**World Forum for Harmonization of Vehicle Regulations****Working Party on Passive Safety Provisions****Seventy-first session**

**UN Regulation No. 129 (Enhanced Child Restraint Systems)****Proposal for New series of amendments****Submitted by the expert from the European Association of Automotive Suppliers\***

The text reproduced below was prepared by the expert from the European Association of Automotive Suppliers (CLEPA) to amend UN Regulation No.129 to introduce Lower Tether Straps. The modifications to the current text of the UN Regulation are marked in bold for new or strikethrough for deleted characters.

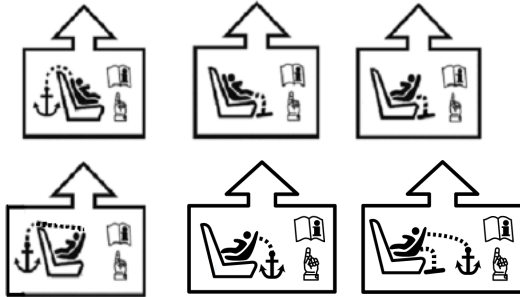
- (c) The position and if necessary, the routing of top tethers, **lower tethers**, or other means of limiting Enhanced Child Restraint System rotation requiring action by the user, shall be indicated using one **or more** of the following symbols as appropriate:

Insert symbol of lower tether and combination of lower tether with support leg

In accordance with the marking of top-tether straps anchorages, lower tether strap anchorages will be marked as well to guide users to install the lower tethers in the correct way and to use the correct anchorages. A reference to the instruction's manual is included as well.

Figure 5  
Arrangement for testing a rearward-facing device, not supported by the dashboard

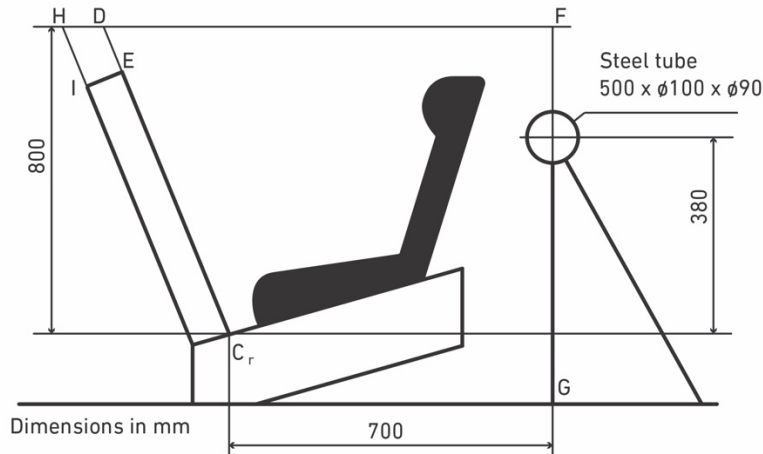
Where a test is conducted with paragraphs 6.6.4.1.6.1.1. or paragraph 6.6.4.1.6.1.2. or paragraph 6.6.4.1.8.2. above, only the second test results without 100 mm diameter bar will be considered. **A tolerance of +10 per cent shall be applicable to the head excursion value distance between Cr point and plane DF and the dummy should not pass beyond the plane HI, parallel to plane DE.**

**Figure 5, amend to read**

By making use of an anti-rotation device without lower tethers straps the tests without lower tether straps in use, should be carried out when there is no mechanism or audible and visual warning system. Since the lower tether straps are relevant to stop the rotation in a rear impact, the relevant plane DF can be passed with an additional 10%, in the same way as defined for forward facing tests with plane AB. For the passage of plane DE, a new plane HI parallel to plane DE is defined, to make the assessment well defined.

Figure 5

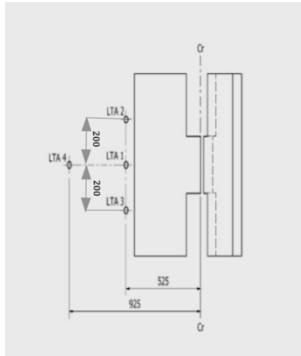
**Annex 6, Appendix 2, figure 5, amend to read:**

**Top View – Bench with Lower strap tether anchorages** (Dimensions in mm; **Tolerance general:  $\pm 2$  mm**)  
(LTA 1, LTA 2, LTA 3 and LTA 4)Dimensions in mm; **Tolerance general:  $\pm 2$  mm.**
